Landscape Review

of the **M3 Junction 9 Improvement**

Prepared for
South Downs National Park Authority

PINS Reference
TR010055

FIGURE 8A
Tree Removal Plan &
LVIA Viewpoints

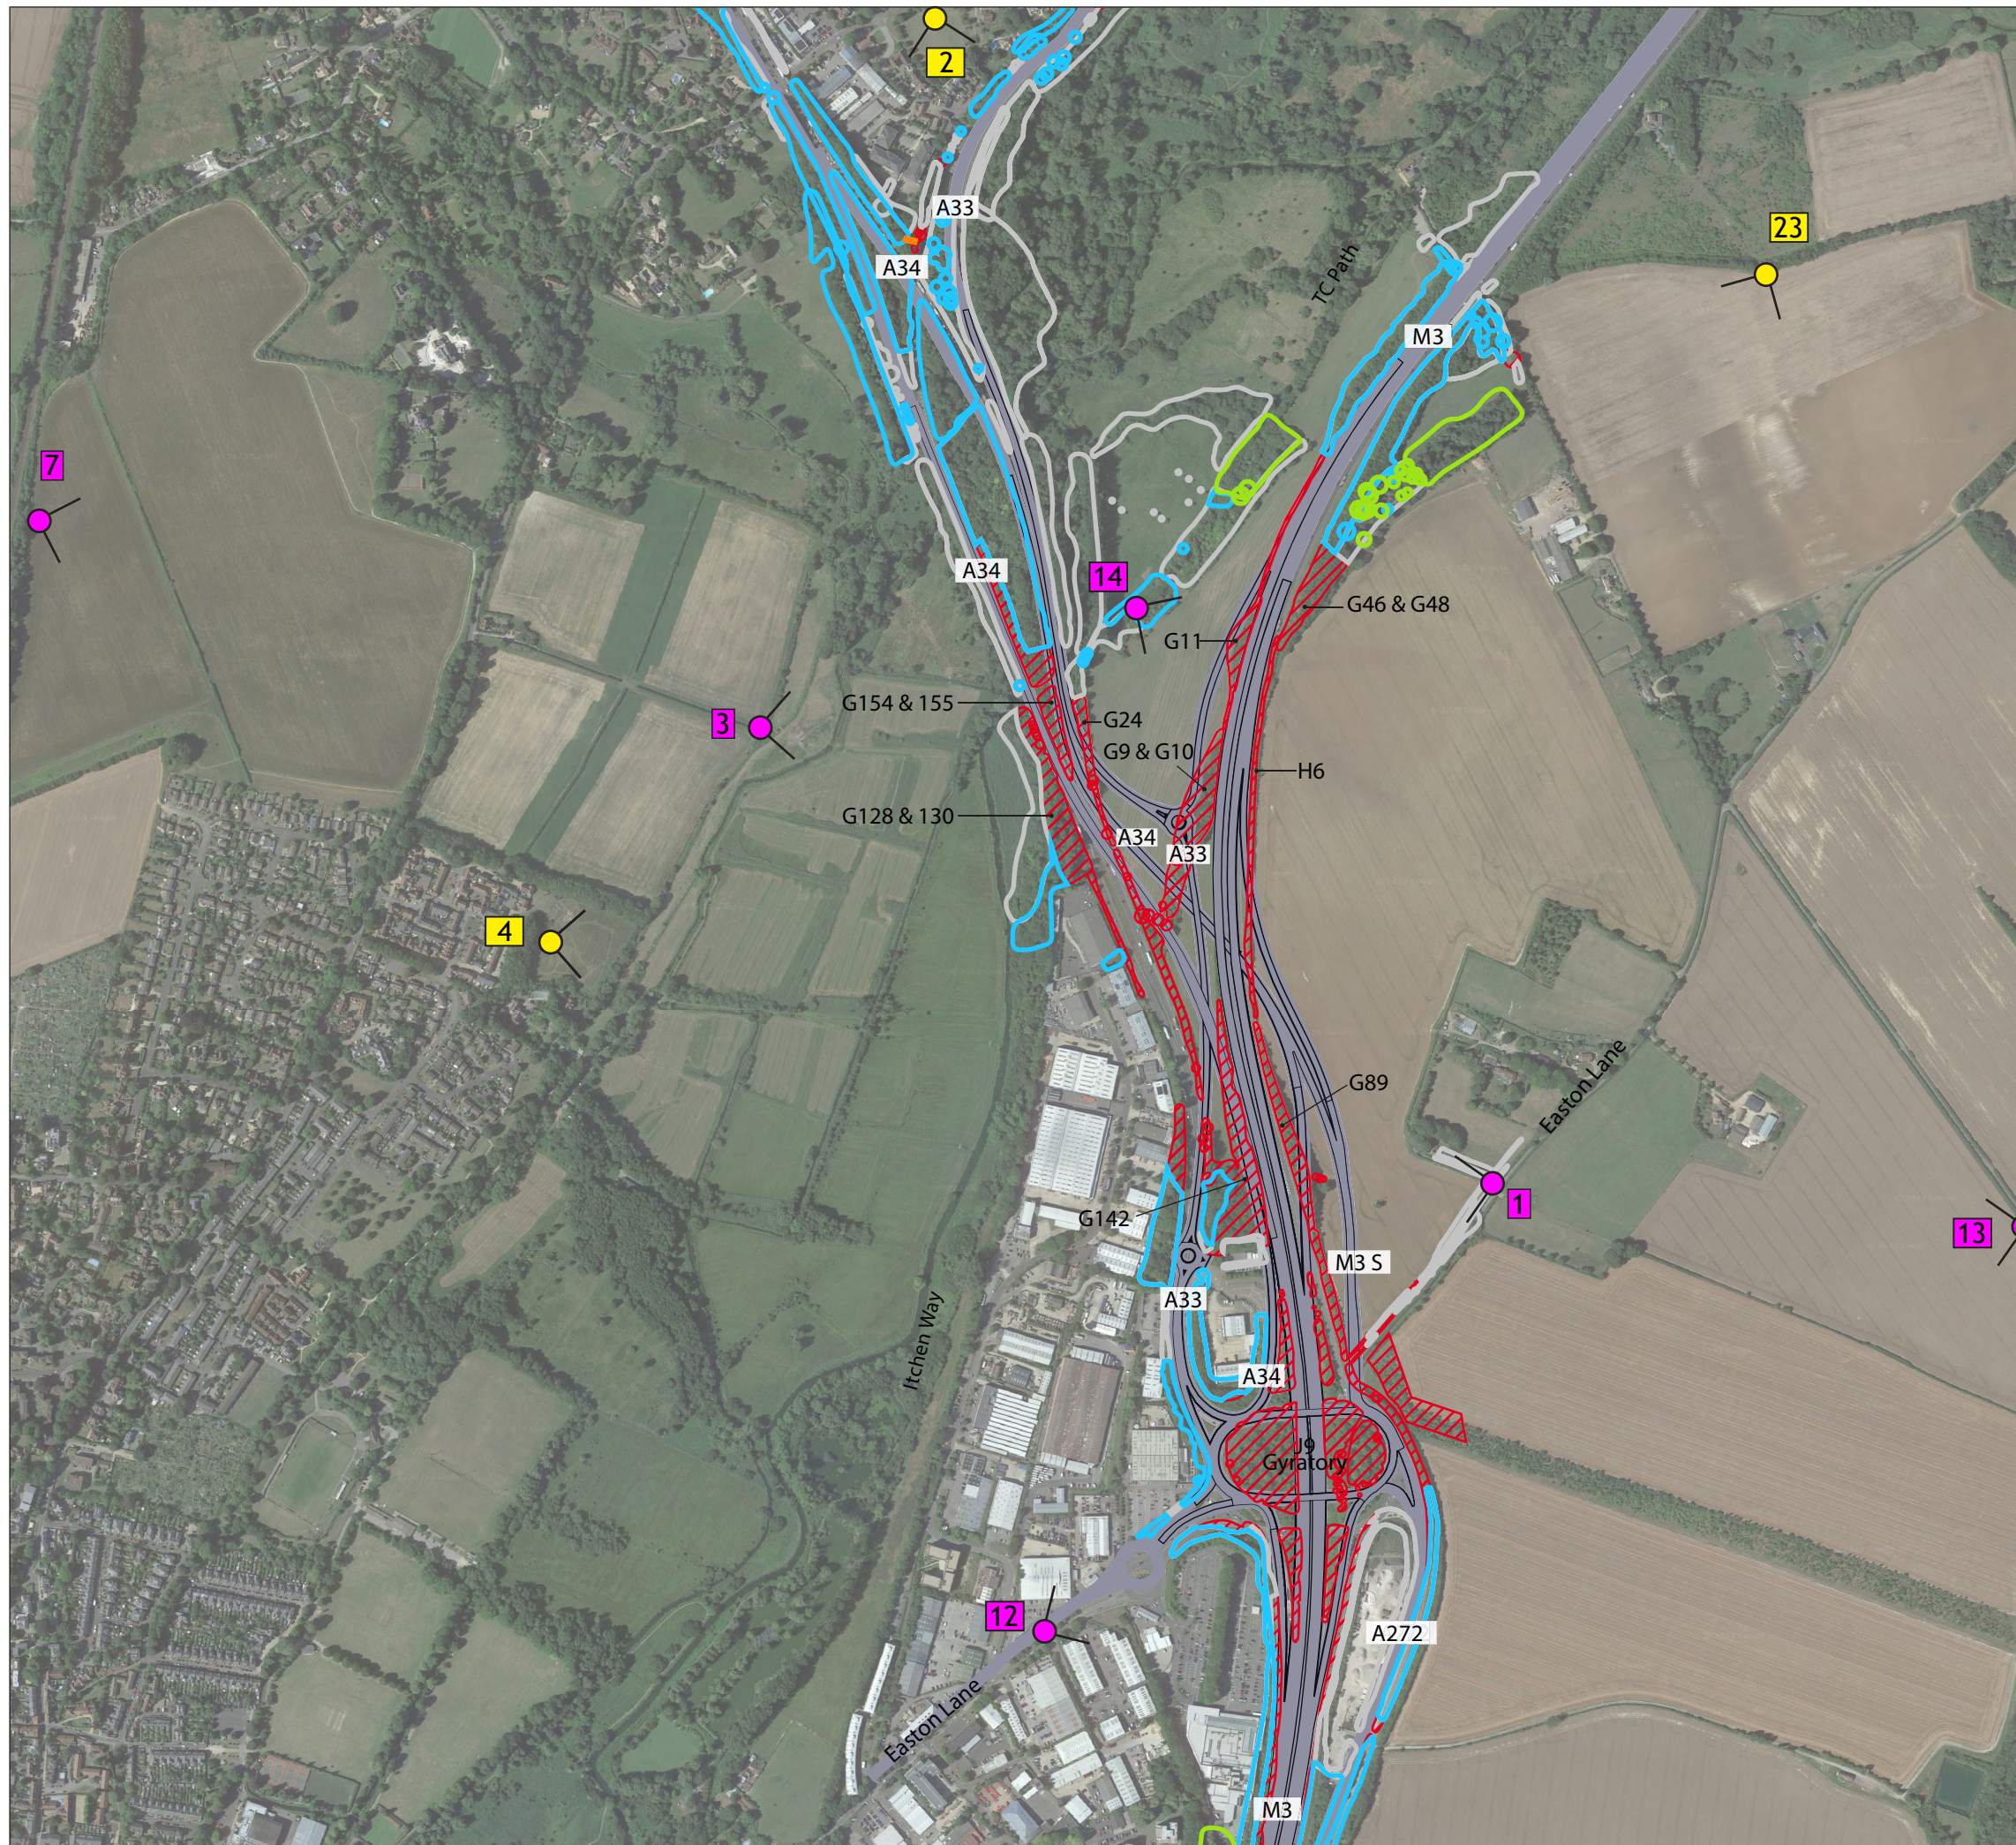
| Summary of Issue | Recommendations | Further Information Requested |
|--|---|--|
| <p>Approximately nine hectares of vegetation is proposed to be removed. Loss of trees along <u>the eastern side of the M3</u> will open up views of the <u>existing motorway corridor, and the proposed new infrastructure roads</u> and increased activity <u>within it, from the east and from the west including from St Swithun's Way on the boundary of the SDNP (SDNP Representative View 62)</u> ⁴.</p> <p>It will also open up views <u>from within SDNP across the valley</u> towards built up parts of Winchester <u>from the SDNP</u>.</p> | <p>Advanced planting is undertaken to minimise the opening up of views as much as possible.</p> | <ul style="list-style-type: none"> • <u>Plan showing the location of the advanced planting, with an explanation for its rationale.</u> • <u>New photomontages from Viewpoints 3 & 7 that accurately show the vegetation to be removed.</u> |

- 1.22 The SDNPA disagrees with the conclusion with regard to the effects from Vp 3, that at year 15 the magnitude of change would be negligible. Trees to be removed cannot be fully mitigated and traffic on the new sections of slip road are likely to be visible from St Swithun's Way.

~~6.56.6~~ Drawings within NH's Arboricultural survey show the extent of vegetation which is proposed to be removed²⁴ (see red shading on Figure 8). These drawings show that the greatest extent of removal will occur in the landscape immediately around the existing gyratory and the landscape north of the gyratory and east of the M3 in which the bulk of the highway works are proposed. When measuring from our Figure 8, approximately nine hectares of vegetation is proposed to be removed. Virtually all existing vegetation alongside the M3 corridor will be removed. Trees along the eastern edge of the M3 currently ~~softens~~soften the interface between the motorway and the SDNP and ~~is~~are relatively successful in minimising the visual impact of the motorway on the wider SDNP.

FIGURE 9A
Environmental Masterplan & LVIA Viewpoints

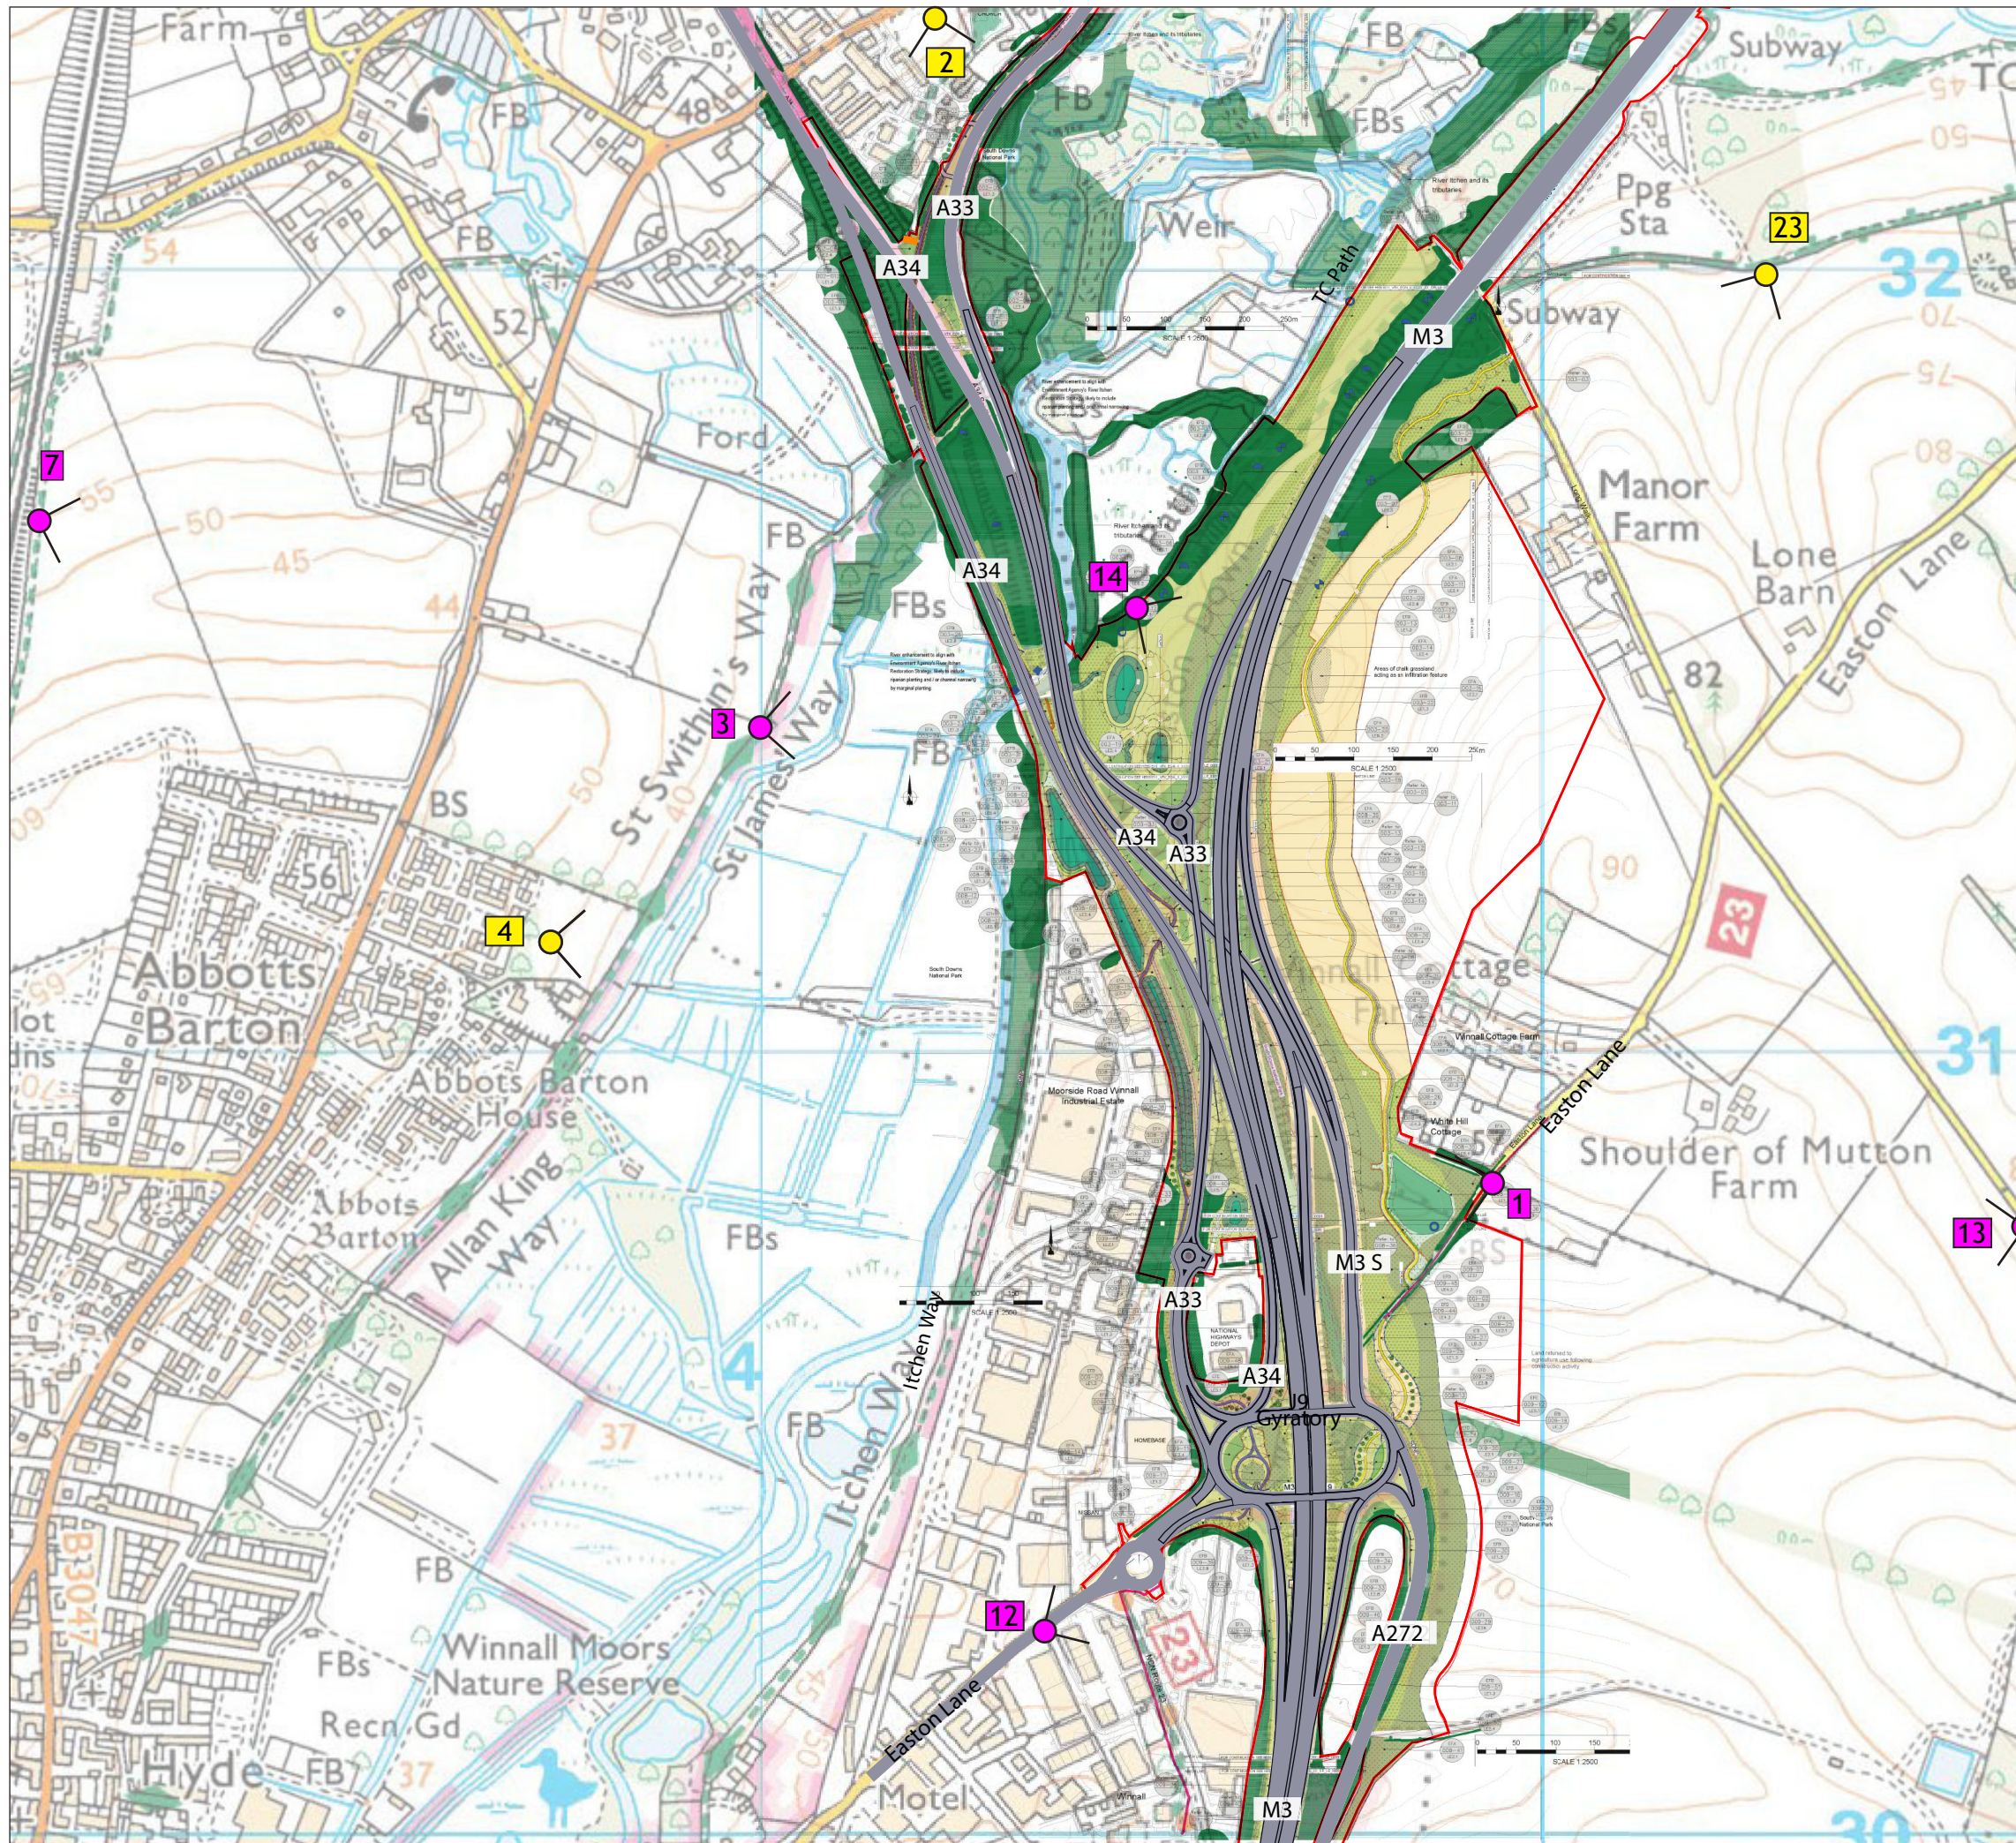
Masterplan (EM) (Figure 9) and due to the amount of information on the EM, they are difficult to read. A shaded relief plan will be the easiest way for the Examining Authority to understand the proposed changes in level and should be provided by NH.

6.86.11 In places the width of proposed tree planting alongside the eastern edge of the M3 is only 10m wide which is unlikely to be sufficient to provide a robust level of screening of the road infrastructure and activity, particularly in the short term, for people within the SDNP e.g., Easton ~~La~~ Lane, Long Walk, and the proposed bridleway between these lanes. In some areas, the proposed tree planting is narrower than the existing level of tree cover that would be removed, which is up to 25m in width (**Figure 9**). Further, in some areas the majority of the proposed planting is located on the cut batter rather than above the slope, where it would be more effective at providing visual relief in views from higher ground east within the SDNP. We recommend that as a design principle, tree planting along the eastern edge of the

motorway is no less than 25m in width and that at least half of this planting occurs on top of the cut batter where it will be more elevated and will provide more effective screening.

- 7.1 The proposals include an approximately 875m long swale alongside the proposed bridleway between Easton Ln and Long Walk, and an attenuation pond at the south eastern end of the site (**Figure 9**). The attenuation pond would be located immediately alongside the proposed bridleway. It would be visible from the bridleway as well as from Easton ~~Ln~~ Lane. The swale and pond would be located east of the M3 within the open downland landscape type. These features would be incongruous within the chalk downland landscape which is otherwise characterised by large open arable fields over rolling downs and dry valley systems. The swale and attenuation pond, and the associated earthworks required to form the pond, would not read as part of the downland landscape but as part of the overall highways landscape, which would be perceived as having extended into the downland. Loss of the open download character would be exacerbated by proposals to enclose the pond at the south eastern end of the site with scrub and woodland planting - the type of planting which is currently largely restricted to the lower valley sides and valley floor. These features would neither conserve nor enhance the natural beauty and character of the SDNP in a location where there is significant interaction between the public, the SDNP and the scheme.

- 7.2 There are no plans which show the proposed contours for the attenuation pond. Neither its proposed depth, nor the steepness of its slopes. However, with a footprint of approximately 4,200m², it would be seen as a large engineering feature in the landscape. Further information should be provided by NH explaining the detailed design of the attenuation feature and the swale, and the measures taken to ensure that any potential environmental benefits of these features have been maximised.

- 8.1 The proposals for chalk grassland within the landscape east of the SDNP would establish a new line or sub_division within the open downland. This is because the area proposed to be managed as chalk grassland would not correspond with any existing field boundaries (**Figure 9**). Instead, the outer extent of the proposed chalk grassland is arbitrary as it has been drawn using a 100m offset from the proposed bridleway. The remainder of land within the Order Limits east of the grassland would continue to be used for arable production. These differences in management regimes would establish a new pattern in the landscape, which would not correspond to any existing or historic patterns. Furthermore, it is unclear how the chalk grassland would be protected from agricultural activities and management practices which might undermine or disturb the chalk grassland.

~~6.46.5~~ ~~Once the above information has been received, we will be able to provide more detailed comments on the topography.~~ As a design principle, we recommend that the existing flowing downland topography east of the M3 is conserved as much as possible and that any filling of deposition material is done so in a manner which is sympathetic to this distinctive landform.
